Wellington CBD to Miramar / Seatoun Route 2 Bus Infrastructure Improvements

Concept Stage Safe System Audit

Prepared for:
Wellington City Council

28 August 2025

Figure 5-12: Proposed layout of bus stop 6042 on Monroe Street. INSET: View of bus stop showing large pohutukawa tree potentially blocking the rear door(s) of a longer articulated “bendy” bus.

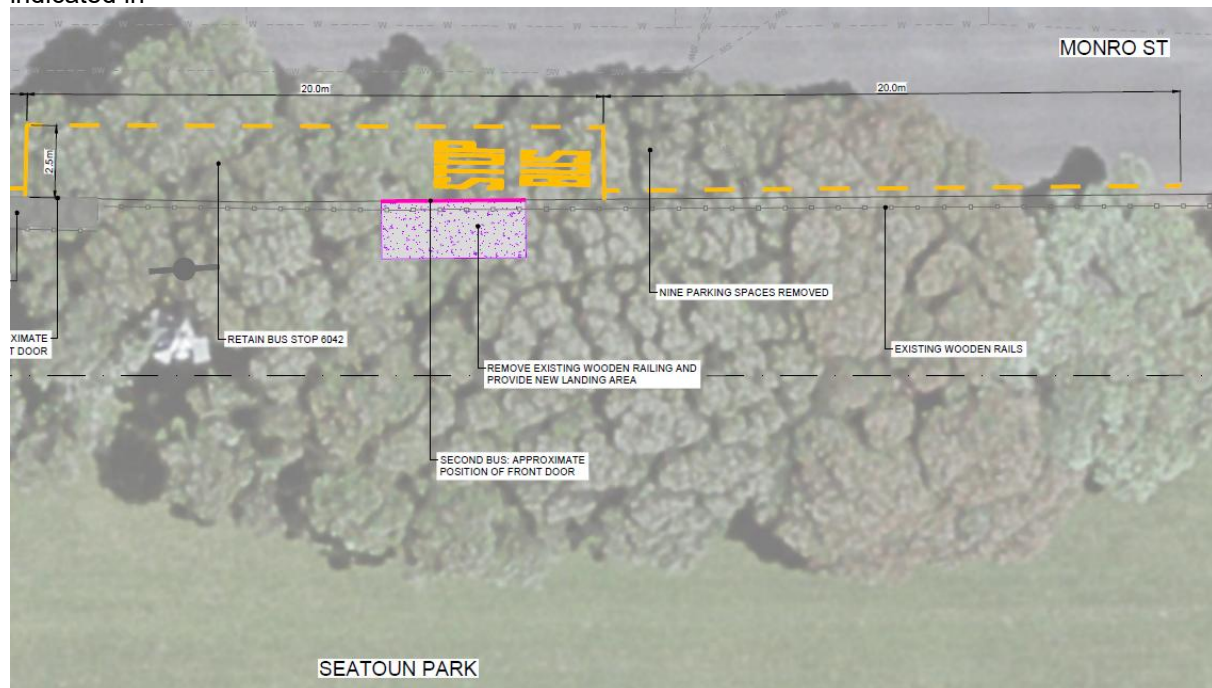
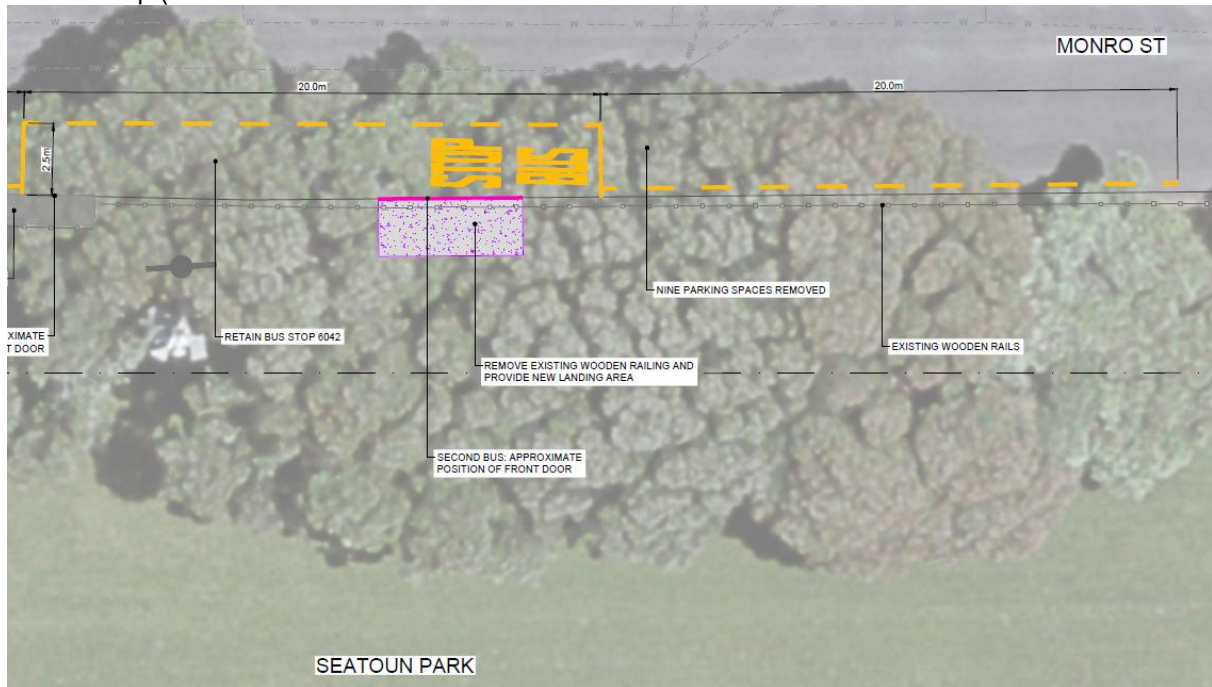
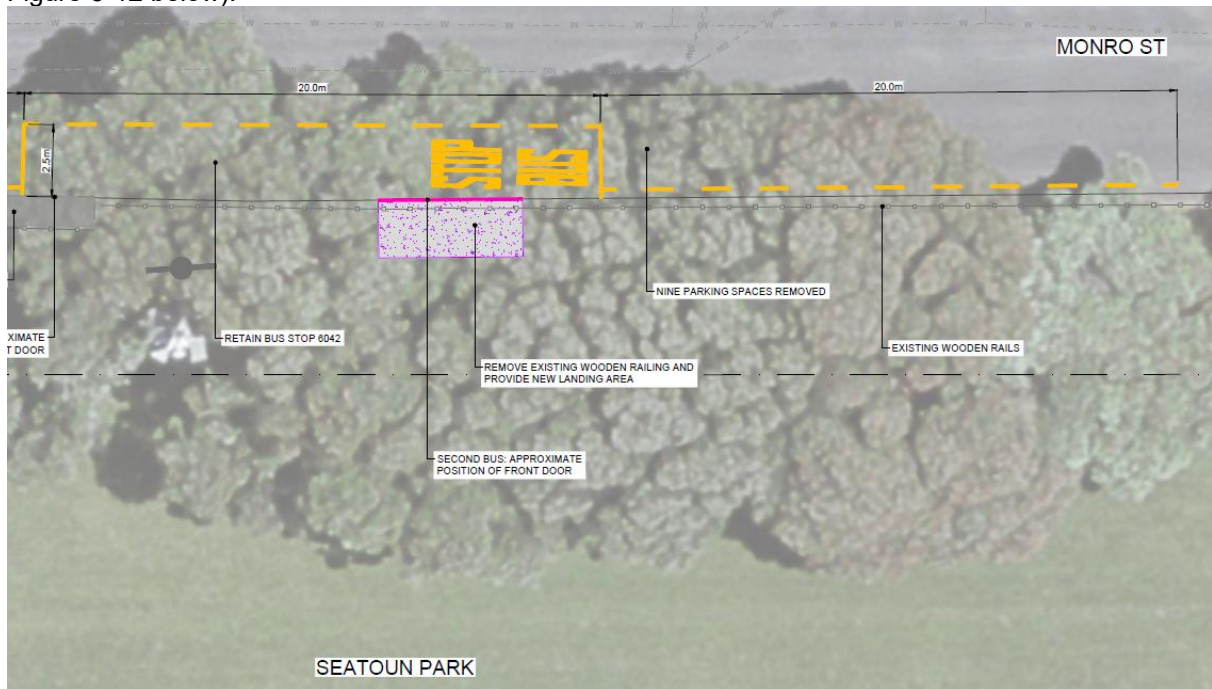
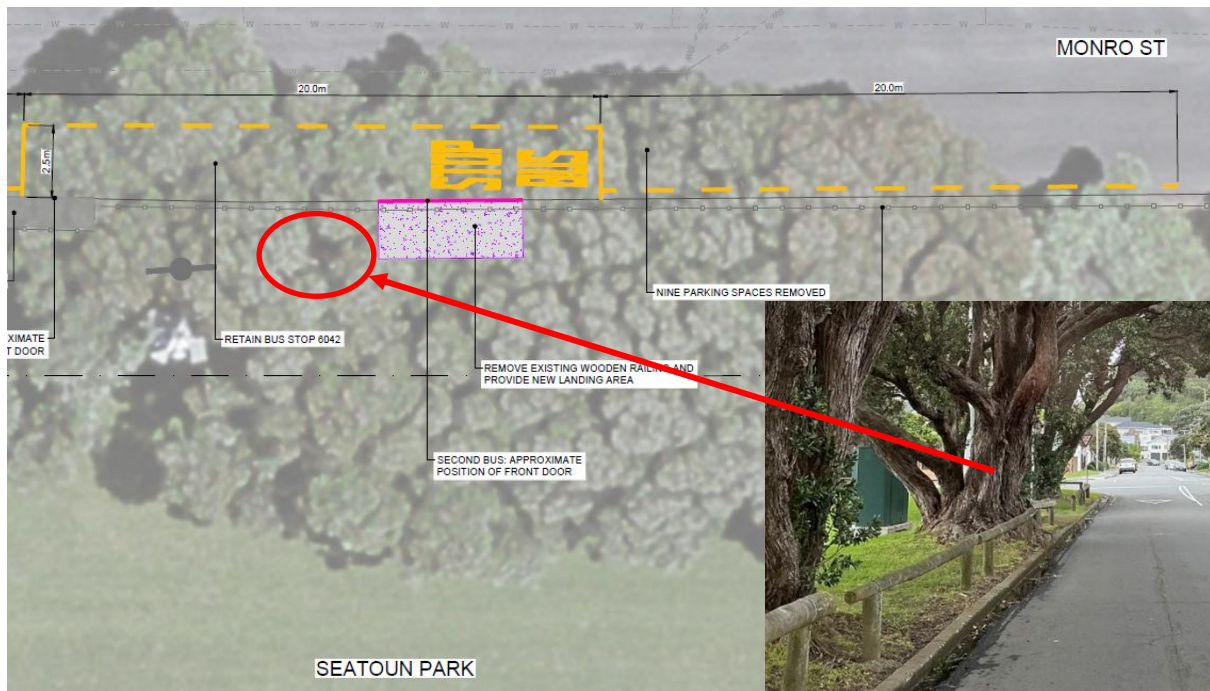
The existing bus stop 6042 on Monro Street is proposed to have a new landing area provided as indicated in

Figure 5-12 below. There are large Pohutukawa trees located along the edge of Seatoun Park and one is positioned directly in front of where the landing is proposed. It is not clear whether the rear door(s) on a longer articulated “bendy” bus would be clear of the large Pohutukawa tree located within

the bus stop (refer to the INSET in

Design team response	<p>Due to the location of the trees along Monroe Street, it is unlikely that both the rear door of an articulated bus and the front door of a second bus could both be accommodated without obstruction of the doors unless tree(s) are removed. The design prioritises providing access to the front door of the second bus, as the articulated bus is accessible via its front doors.</p> <p>An alternative option could be to provide a kerb buildout with a platform in front of the trees, converting the stop to an inline stop.</p>
Client safety engineer comment	Further work required at the design stage to identify the preferred solution.

Client decision	Agree with responses and comments. Detail design to define appropriate solution. Cost to be considered, then additional benefits for access.
Action taken	Direct designers to investigate appropriate solution within cost and as per conversations with accessibility community.
